NOVI ACRES JSP 25-0012

Public hearing at the request of Cypress Partners, LLC for recommendation to the City Council for Amendment of the Consent Judgment that governs development of the property. The applicant is proposing a 61-unit multi-family residential development, a standalone retail building, and associated parking.

3rd Revised Site Plan and Request to Amend Consent Judgment

DRAWING NUMBER:
C-3.1

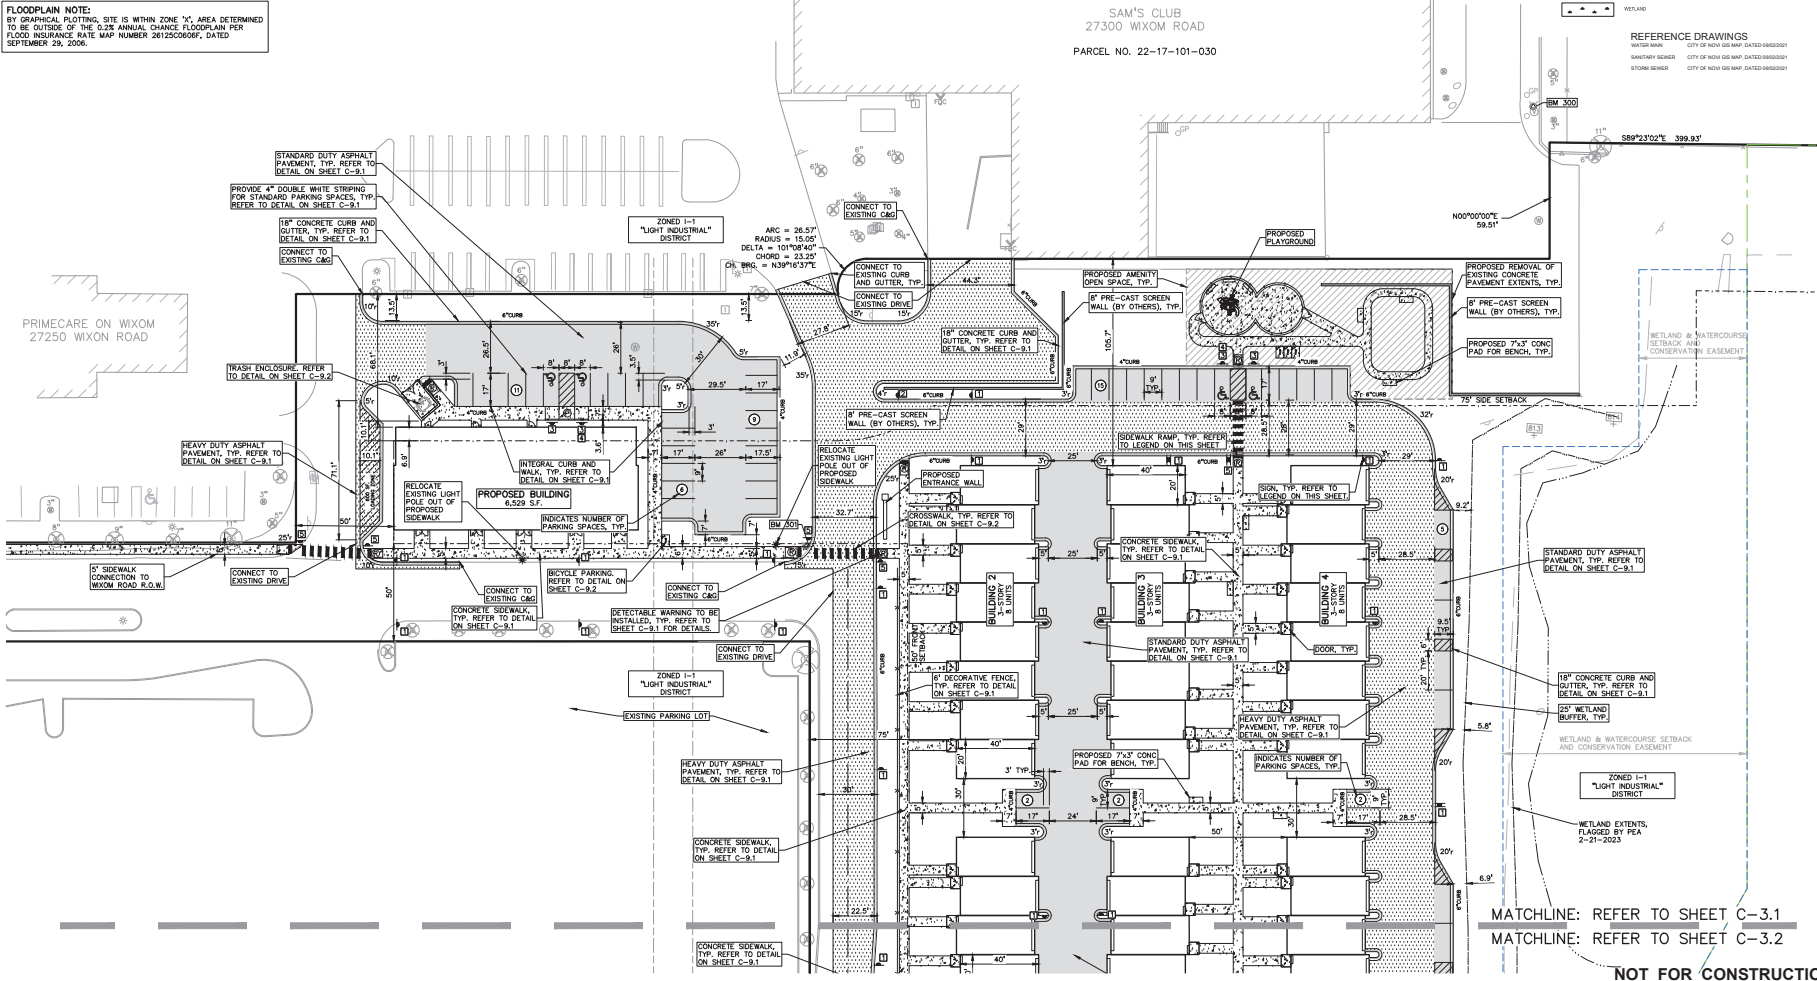
There was also a concern raised in the most recent city review with respect to the city requirements for "usable open space". The June 8, 2026, city planning review, page 7, quoted a portion of the city ordinance which defines usable open space as "courts and yards at grade level devoted exclusively to recreational use." However, city zoning ordinance section 3.1.8.D also includes in the definition of usable open space "balconies with direct access to the dwelling unit." The proposed development includes 61 units, each of which has a balcony with direct access to the dwelling units. The balconies are each 5 feet by 15 feet eight inches which is 78.33 square feet per unit. [$15'8'' = 15.666'$ and $5 \times 15.666 = 78.33$ sq ft]. There are 61 units, thus, the balconies provide, as defined by the city zoning ordinance, 4778.13 square feet of usable open space. [$61 \times 78.33 = 4,778.13$]. The city's zoning ordinance requires usable open space of 200 square feet per dwelling unit. With 61 dwelling units included in this development, that would be a requirement of 12,200 square feet of usable open space. In addition to the 4,778.13 square feet of usable open space provided by the balconies, the applicant is now providing an enlarged amenity open space in the northeast portion of the development. This was originally an open area for use by the residents. After recent discussions with the city, it was recommended that this be expanded and that a play structure for the children of residents be provided. With this most recent submission we have significantly expanded this open space area which now includes a proposed playground with a play structure. The dimensions of the newly proposed amenity in the northeast corner includes an additional 7610 square feet. This along with the 4,778.13 square feet of usable open space provided by the balconies provides a total of 12,388 square feet of usable open space which exceeds the city's requirement. Thus, a deviation is no longer necessary as this requested deviation has been eliminated and the applicant proposes usable open space in excess of that required by city ordinance and specifically addresses provided open space for use by children of the residents. See Site Plan Sheets C 1.3 and C 3.1 and the Toll Brothers renderings.

DRAWING TITLE
**PRELIMINARY
LANDSCAPE
PLAN- OVERALL**

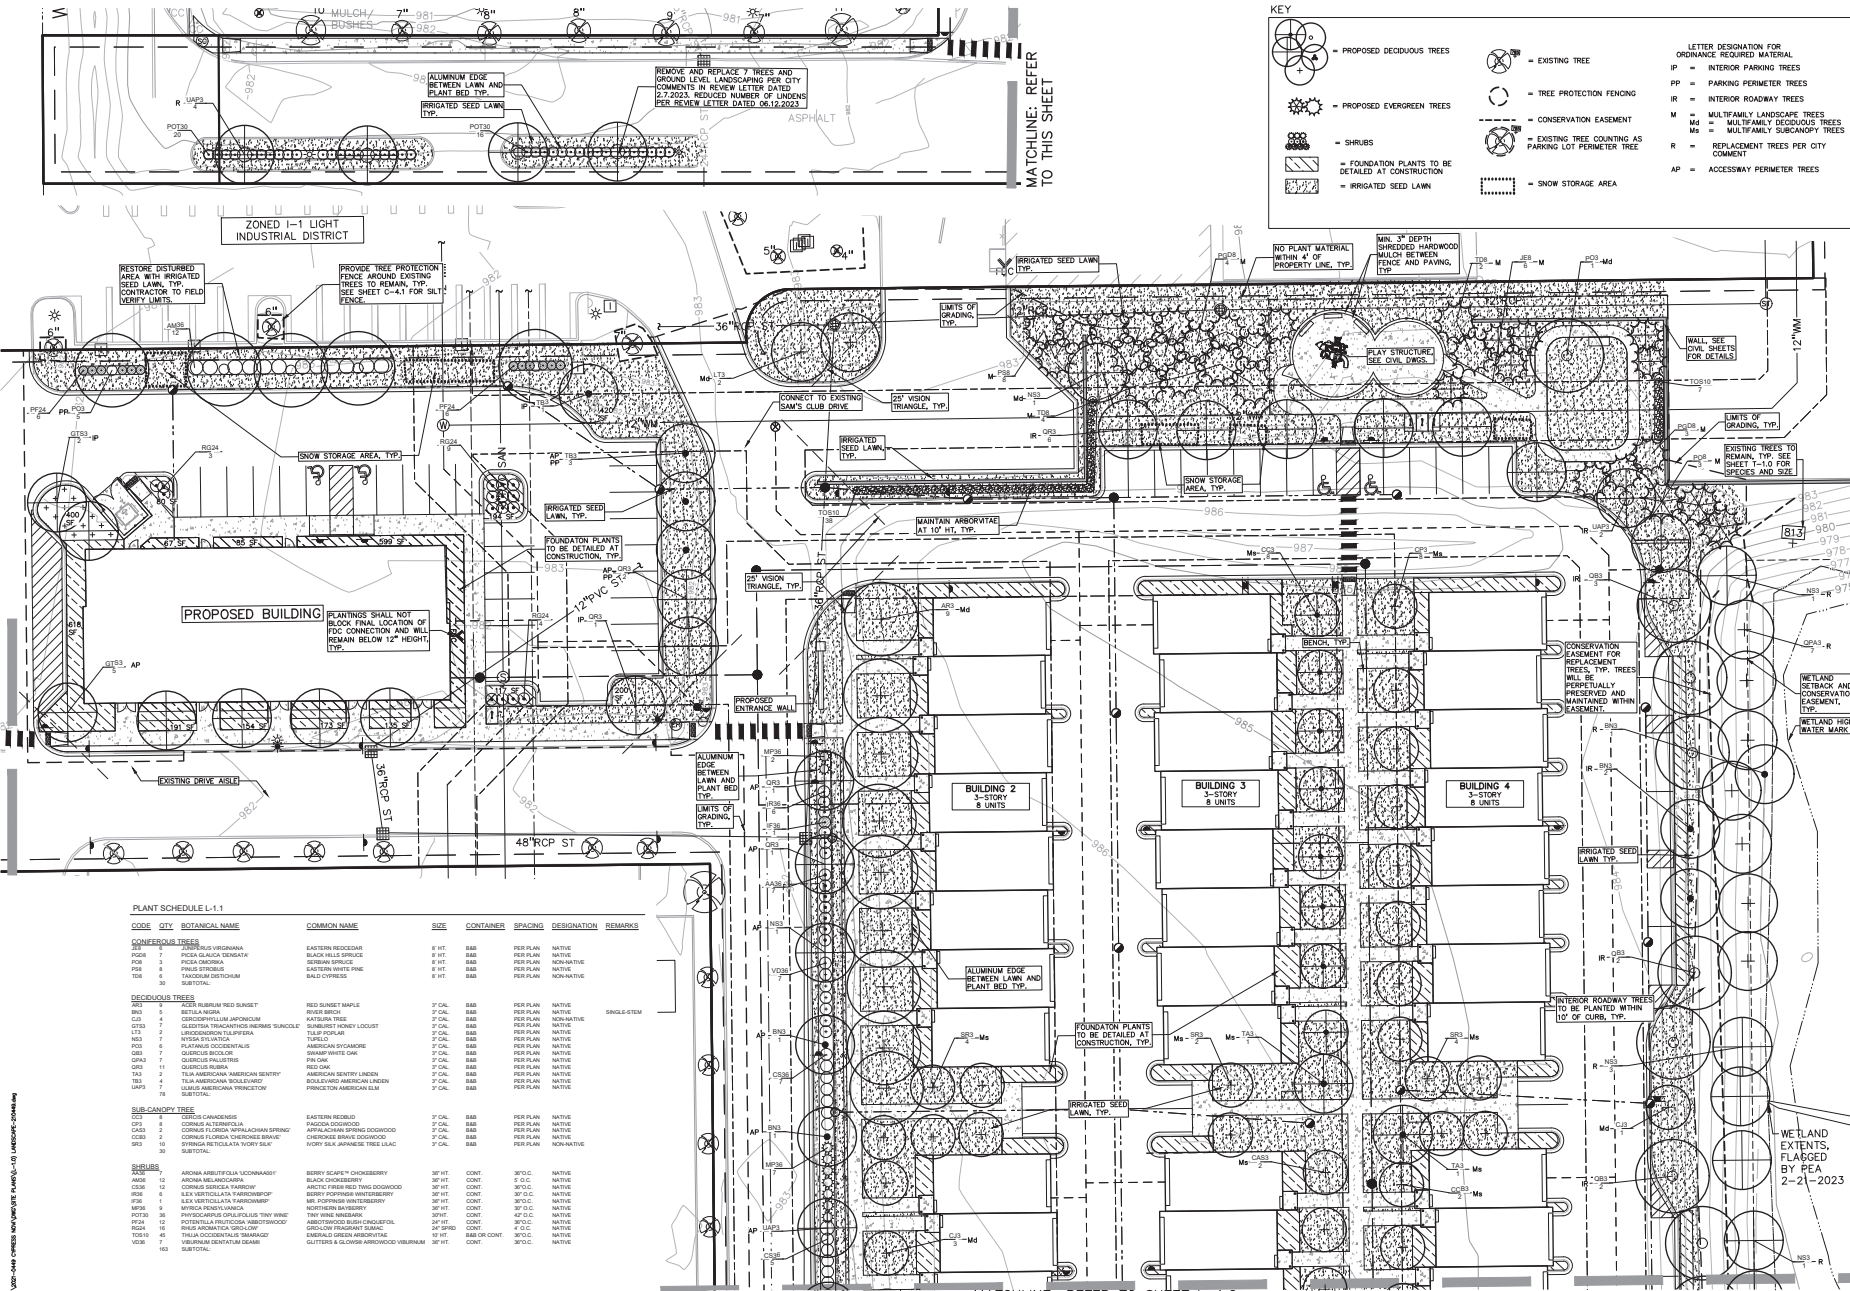
numbered 1, 4, 7, and 8 which have frontage facing drives. City ordinance calls for 35% foundation landscaping, and the applicant had only been previously able to provide less than 7%. Given the site constraints the applicant is proposing that we match the similar building landscaping that has been approved and is being provided at the residential development at Main Street. Below is a photograph of the foundation landscaping at the Main Street project.

Our project is more akin to the urban concept residential which is what the Main Street project is. With this additional foundation landscaping for these four buildings we are now able to achieve 12% for Buildings 1 and 8; 13.13% for Building 4 and 13.33% for Building 7. See Site Plan Sheets L 1.1 and L 1.2 and the Toll Color Renderings.
